Consolidated Edison Company of New York, Inc.  
4 Irving Place, New York, NY 10003  
Telephone (212) 460-2533

November 2, 1984

Re: Indian Point Unit No. 2  
Docket No. 50-247

The purpose of this letter is to apprise you of the upgrading of the fire barriers at Indian Point Unit 2. The upgrading is being conducted in accordance with our submittal of September 9, 1983 and 10 CFR 50, Appendix R. This upgrading was approved in your letter of October 16, 1984.

SKETCH 1

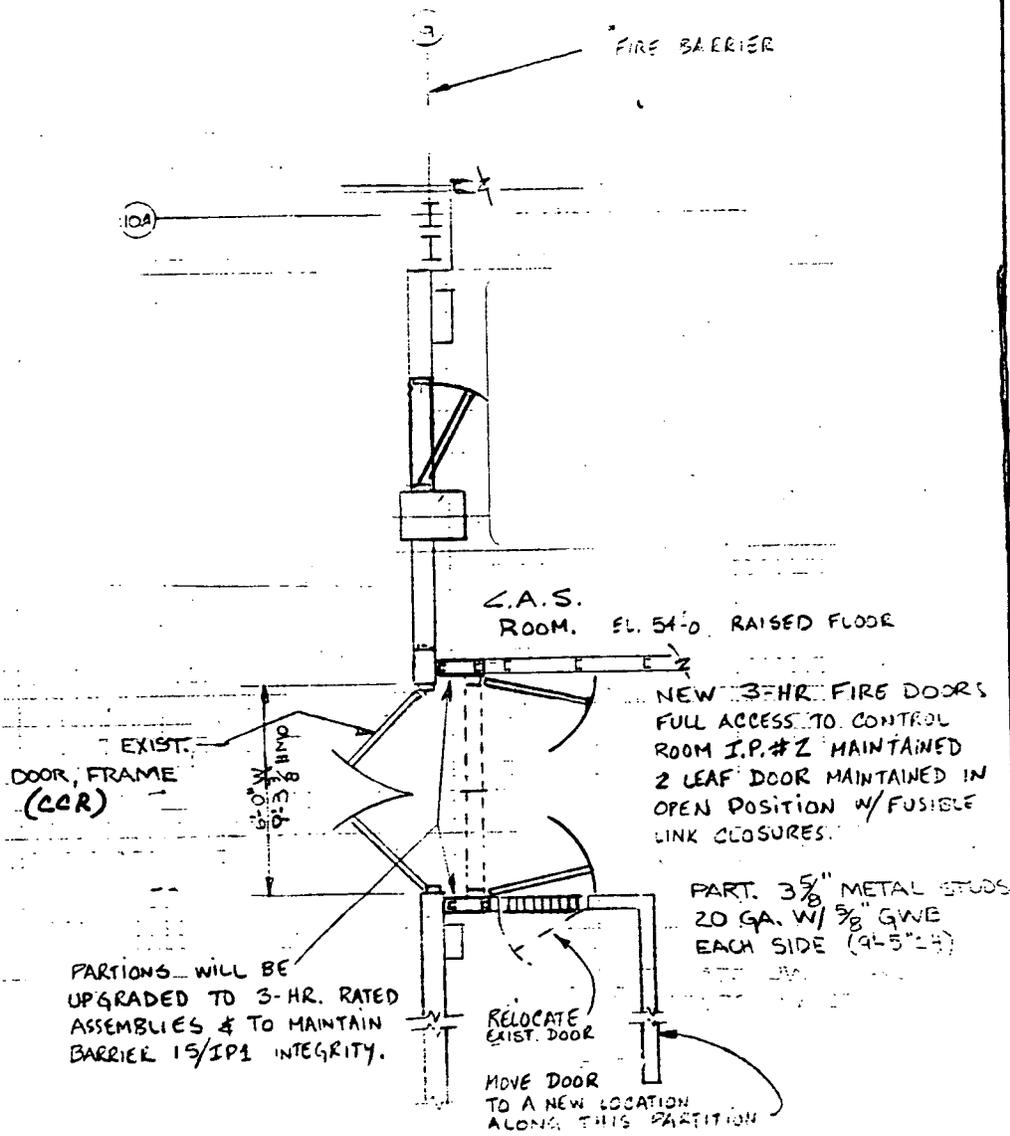
The west control room wall is a Type I fire barrier (3-hour), as described in Enclosure 4 to our September 9, 1983 submittal. There are two doors in the west wall requiring a 3-hour fire rating. The single-leaf door to the Central Alarm Station (see Figure 2-1 of our September 9, 1983 submittal), although not carrying a UL label, is a 3-hour rated fire door modified for security purposes according to the manufacturer's documentation. However, according to UL, the door cannot be labeled due to the security modifications. We have determined that this door is adequate with respect to Branch Technical Position 9.5-1 and our September 9, 1983 submittal. The double-leaf door to the Central Control Room is a security door of a bullet-proof construction with other modifications made to it for security purposes. Although of substantial construction, according to UL, it is sufficiently different that it cannot be considered a 3-hour rated door nor can it carry a UL label. As such, Con Edison is installing a properly rated and labeled double-leaf fire door in series with the bullet-proof door, shown on the attached drawing. We expect to complete this work by March 31, 1985. Because the control room security door is of substantial construction, and the Senior Watch Supervisor's office and Central Alarm Station are adjacent to it and since the control room is continuously manned, we do not consider additional compensatory measures to be warranted in the interim period that it takes to procure and install the fire door.
